STATE OF NEVADA
Department of Conservation & Natural Resources
DIVISION OF ENVIRONMENTAL PROTECTION

December 1, 2010

Nevada Division of Environmental Protection (NDEP) Revised Response to:
Revised Excavation Plan for Phase B Soil Remediation of RZ-C, Addendum to the Removal Action Work Plan, Tronox LLC, Henderson, Nevada

Attachment A

C-Z Rev

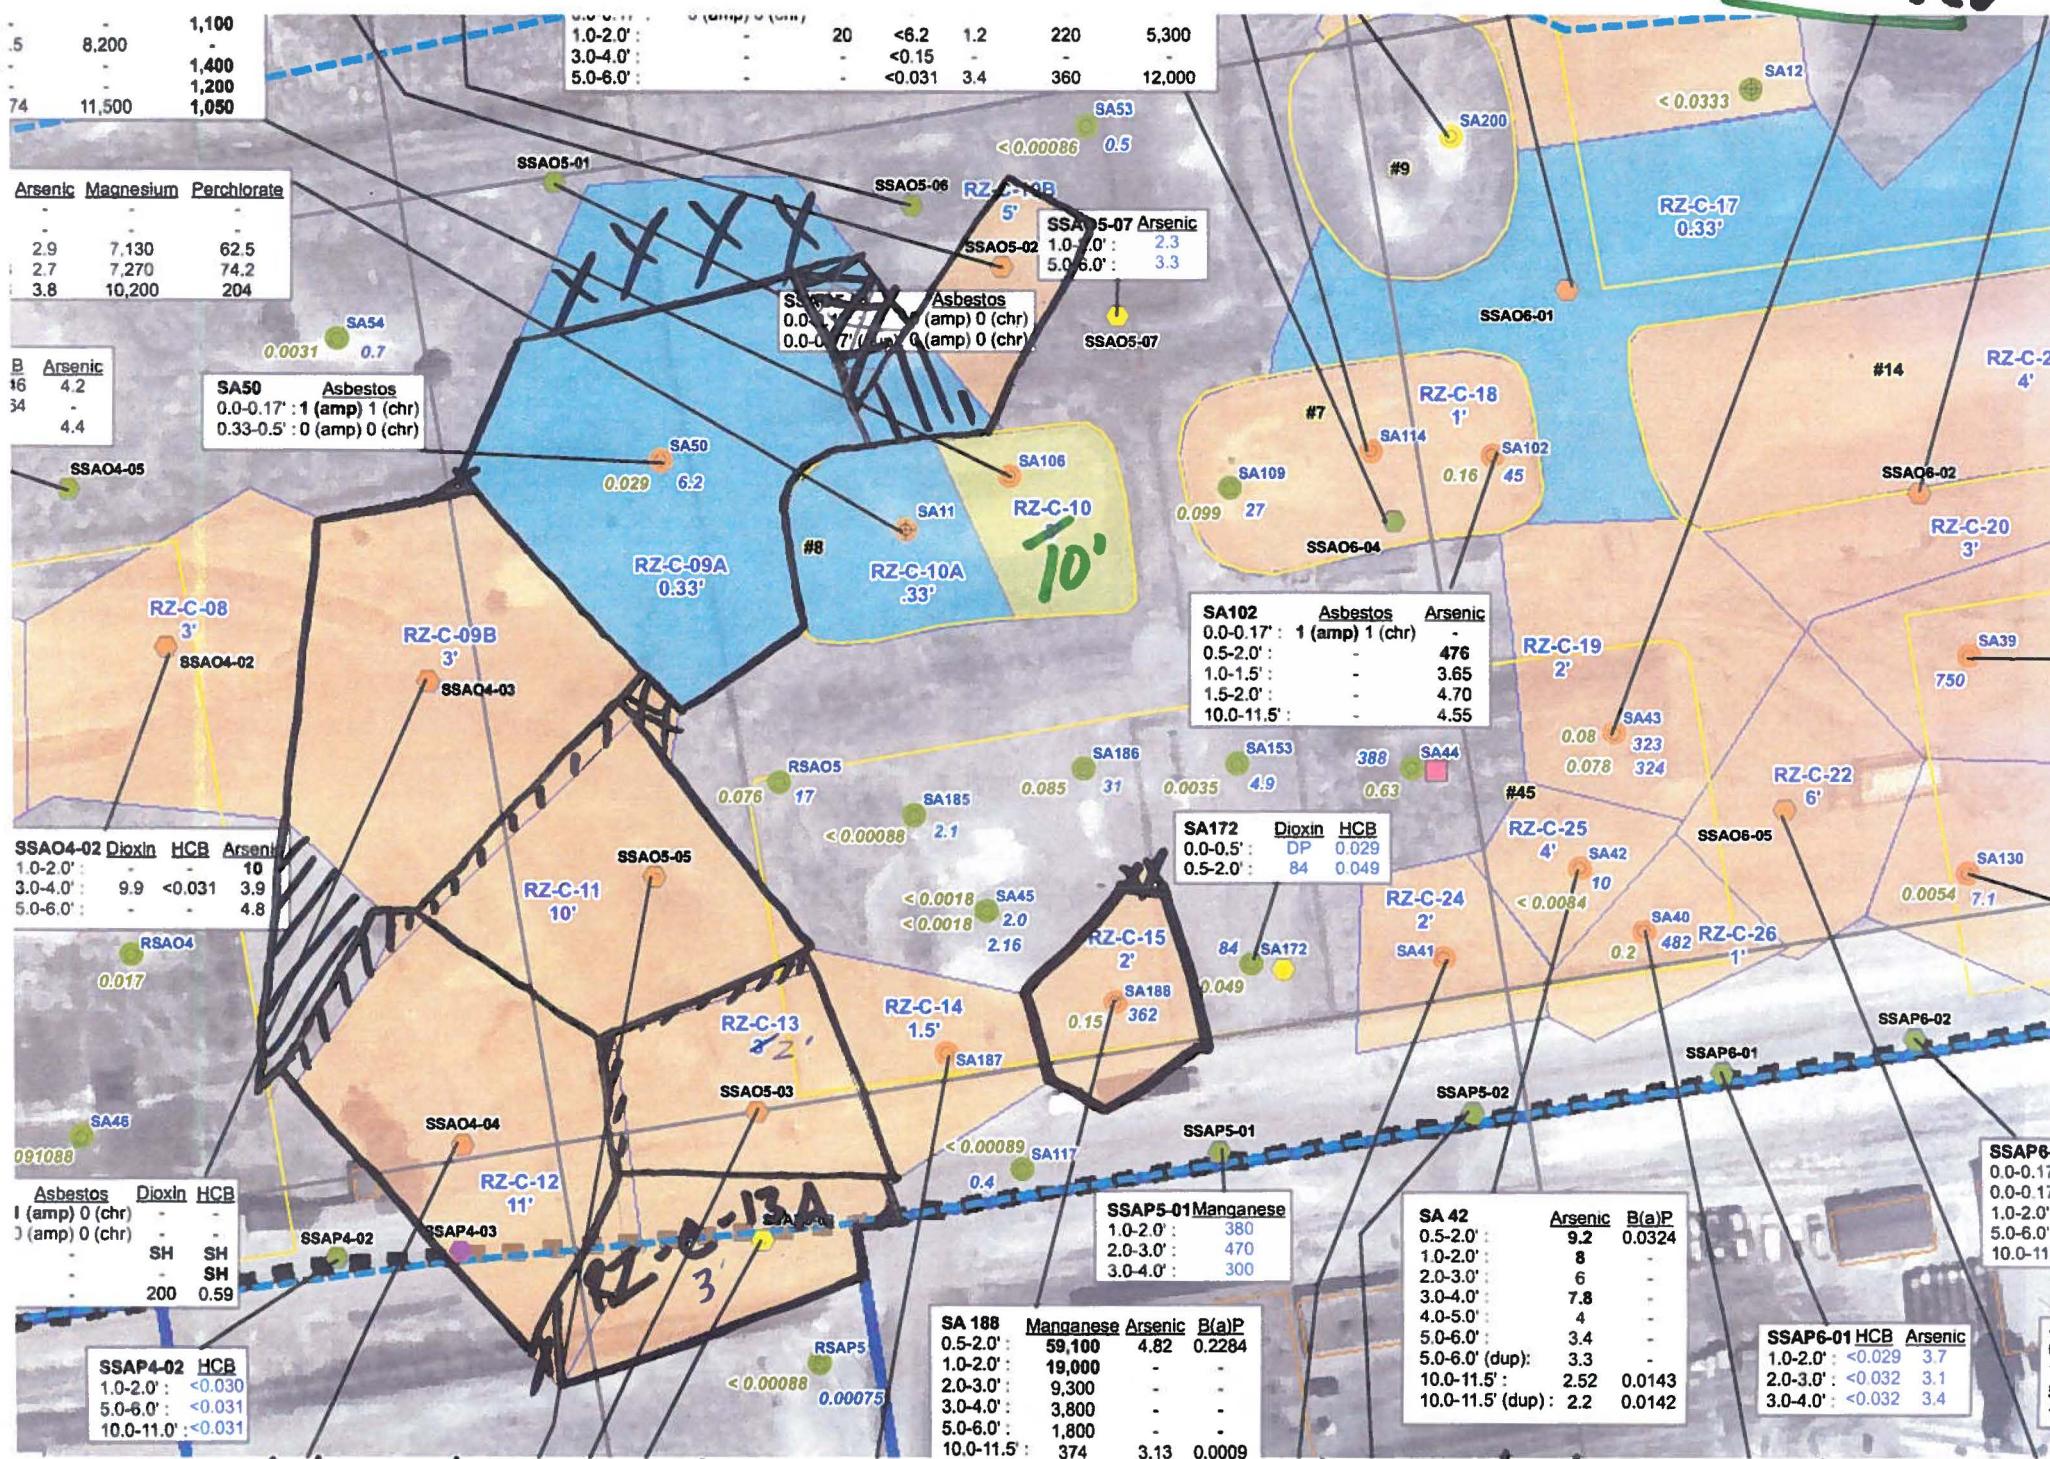
Additionally in this revised response, only Figures C-2, C-4, and C-5 have been revised. The revised depths are marked in green.

* if asbestos results in SA113 are < comparison levels pg 21

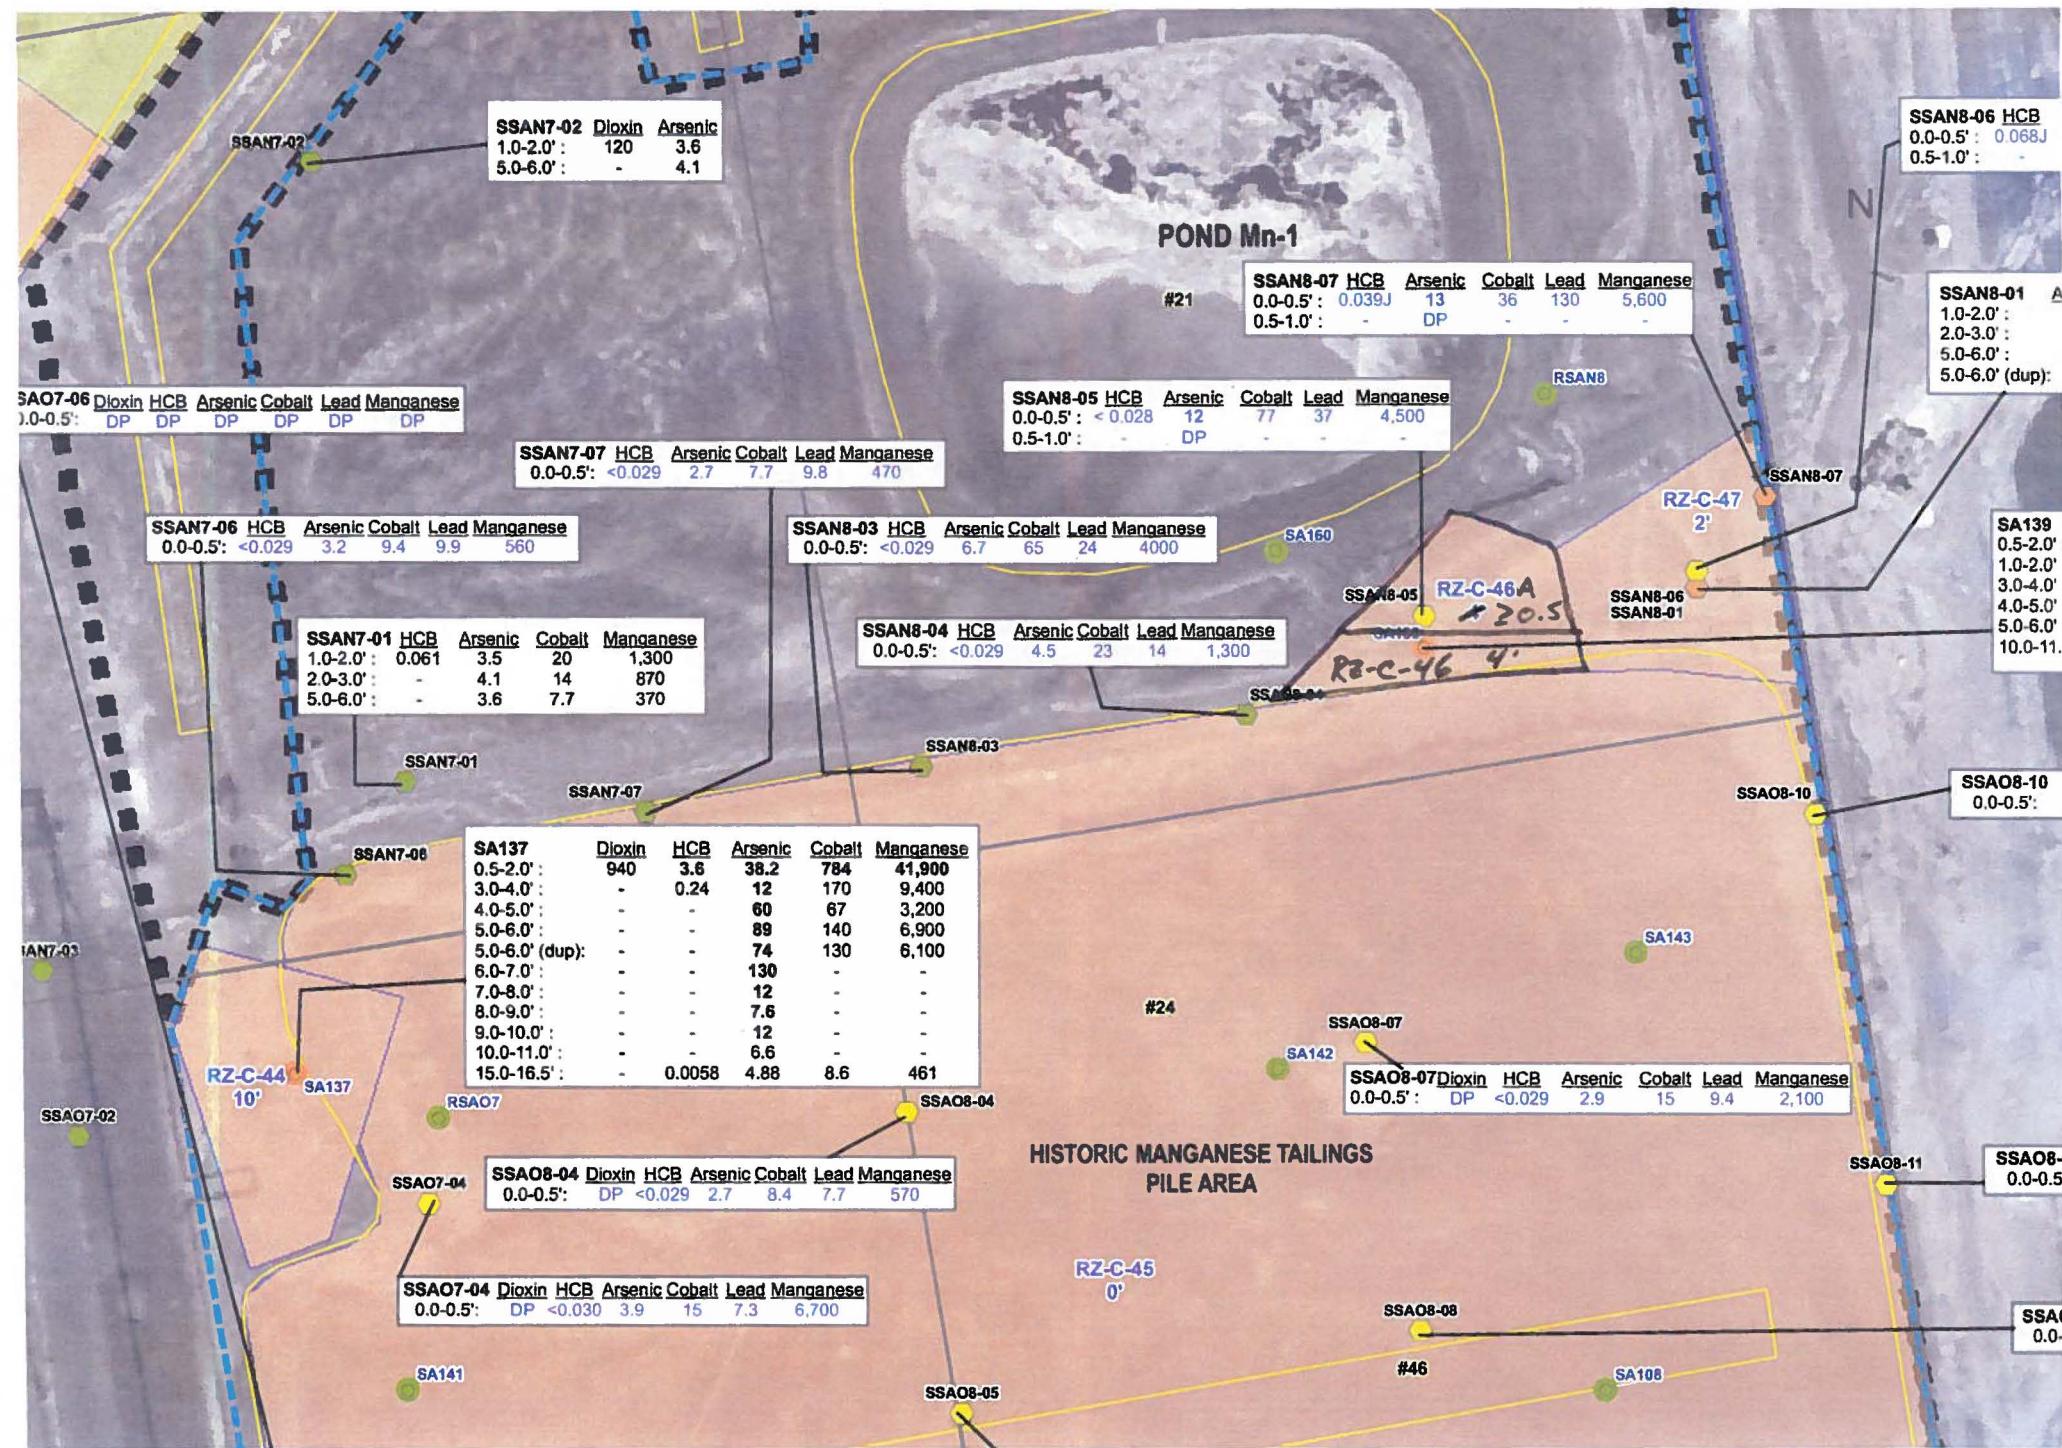
Please note that Figures C-7 and C-8 are included for the revisions that will be necessary once the asbestos results are received for SA113. Figure C-7 is for the scenario where the asbestos results are less than the comparison levels resulting in the reduction of RZ-C-39A. Figure C-8 are for the scenario where the asbestos results are greater than or equal to the comparison levels resulting in the increase of RZ-C-39A.
